REQUEST FOR COMPETITIVE SEALED PROPOSALS

Solicitation Number: B-16-018-AM

2016 METER REPLACEMENT PROGRAM

Addendum 1 – October 21, 2016

2016 Meter Replacement Contract Attachment A

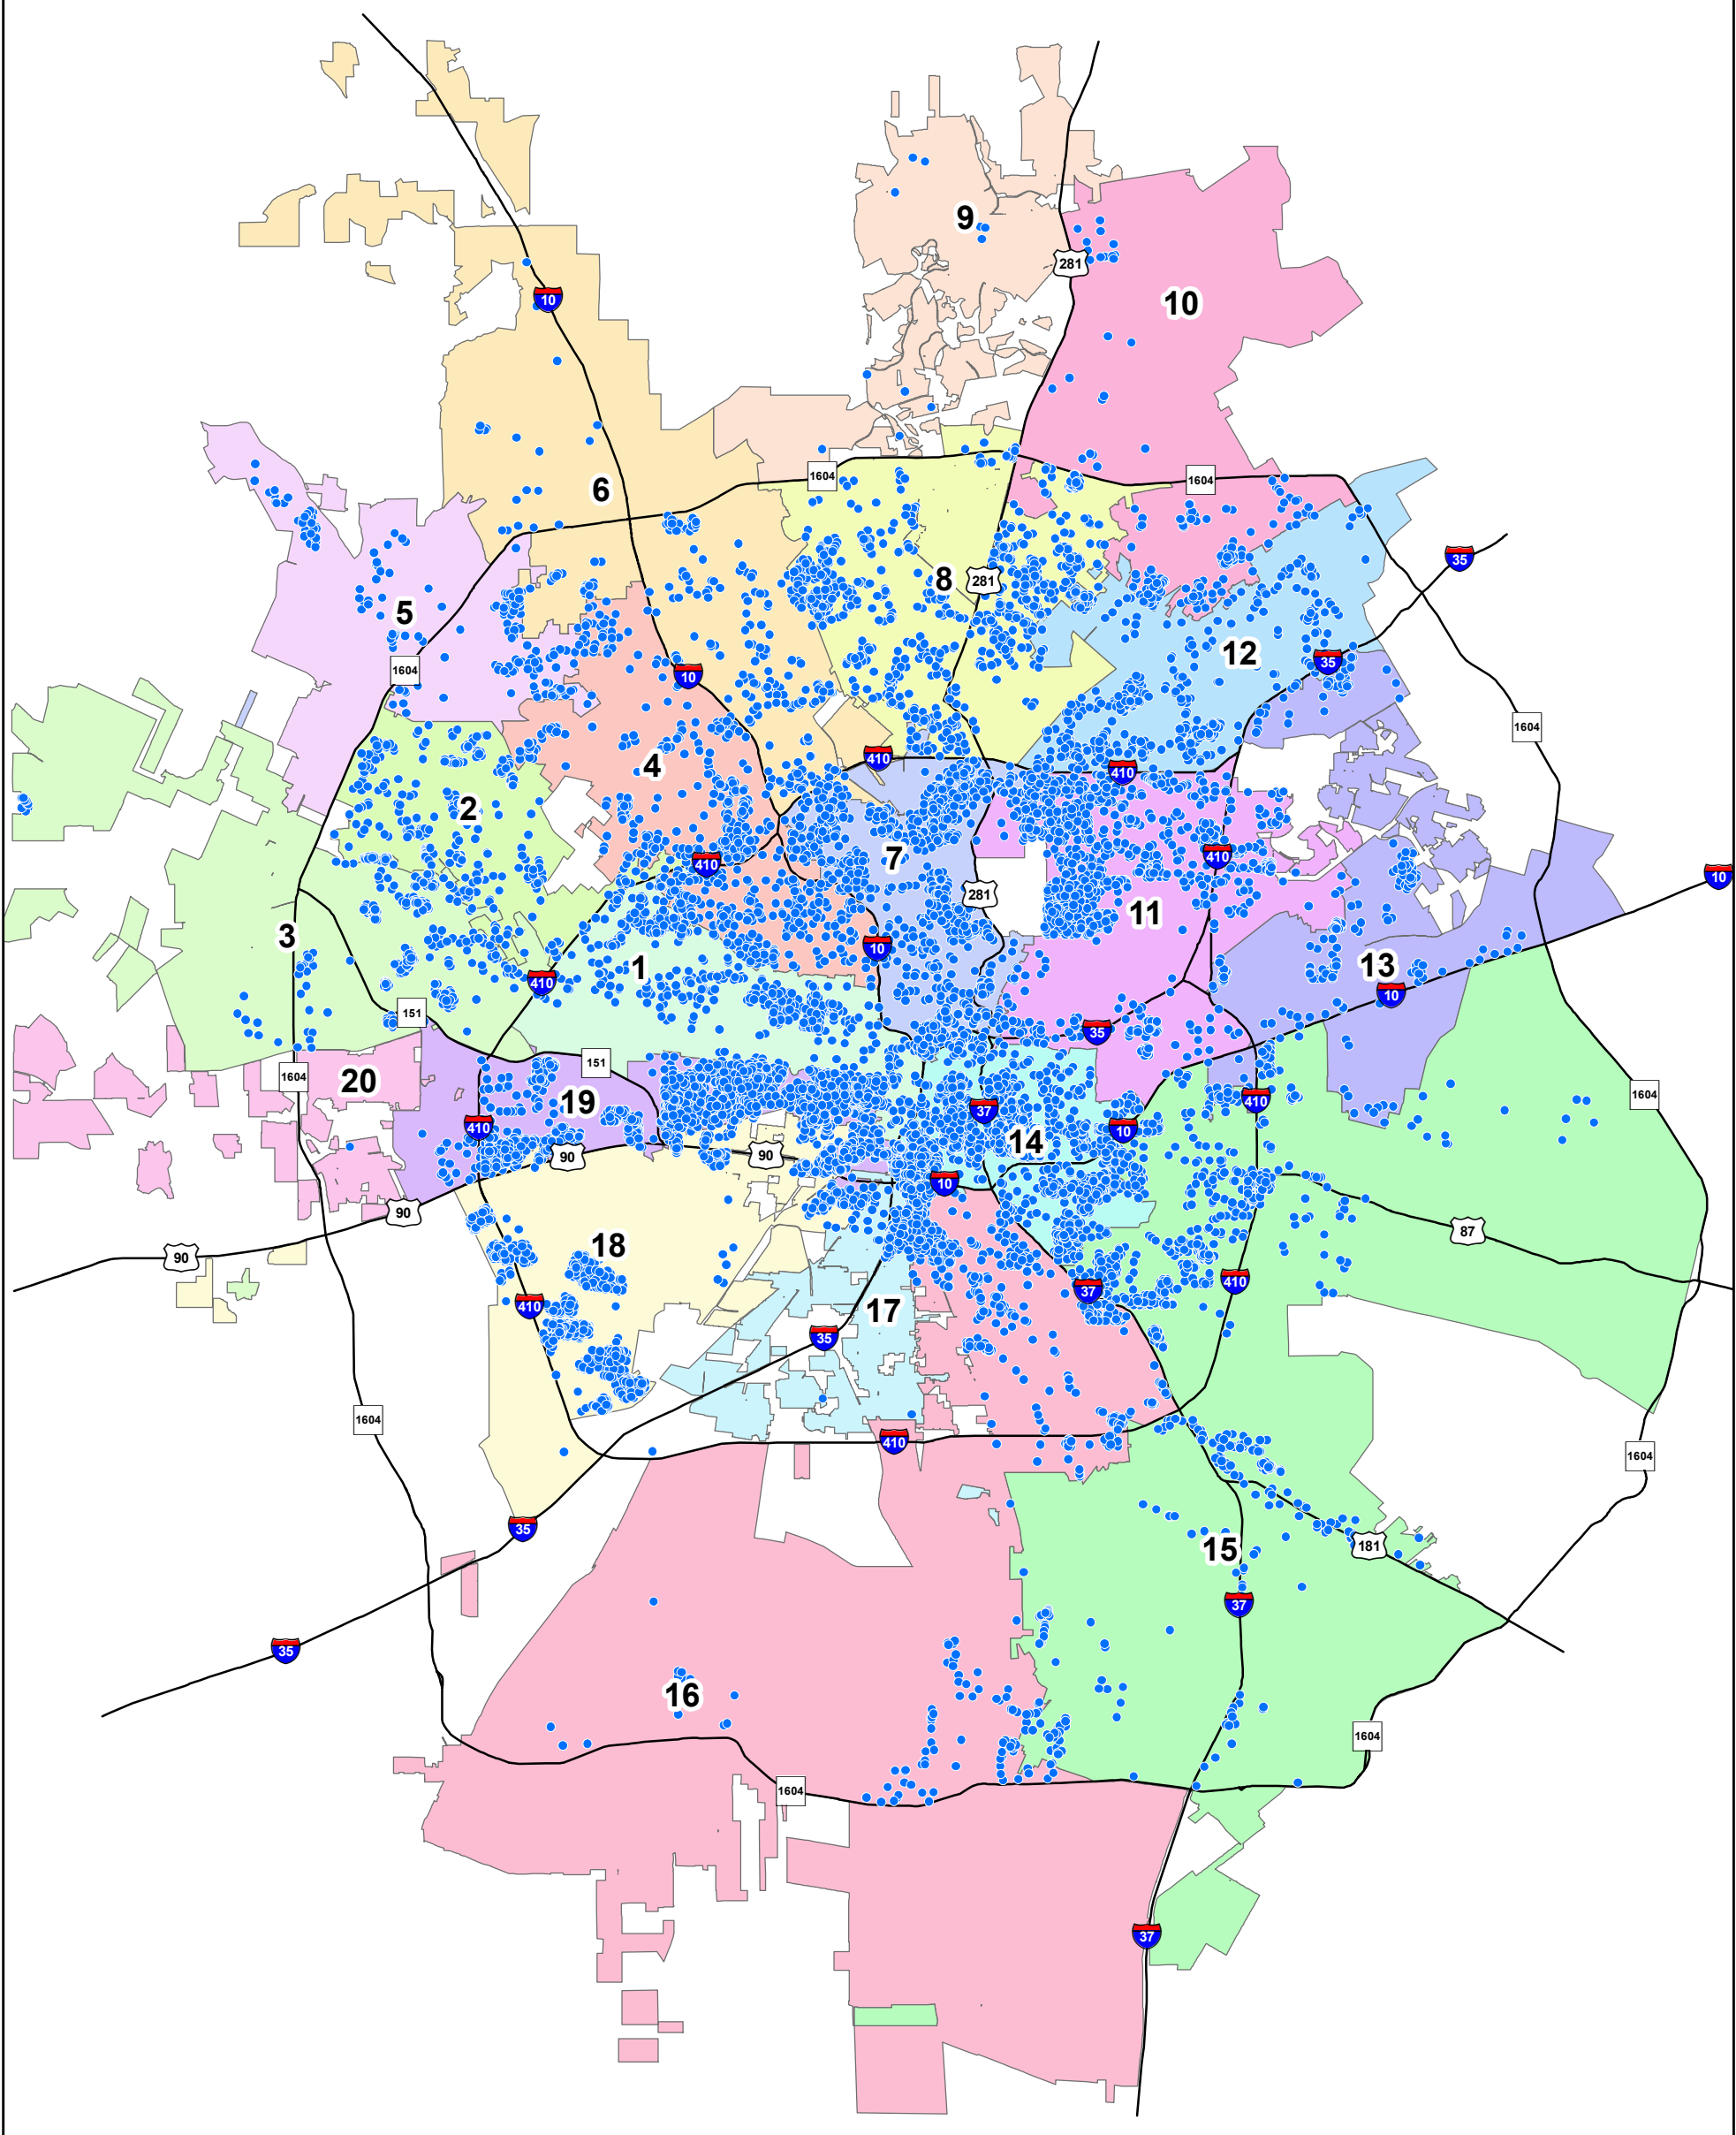
Q36: Where specifically are these installs being performed? Zip Codes, Towns, etc...

A36: Reference Attachment A- Map of Specified Meter Reset Locations. Attached to this addendum.
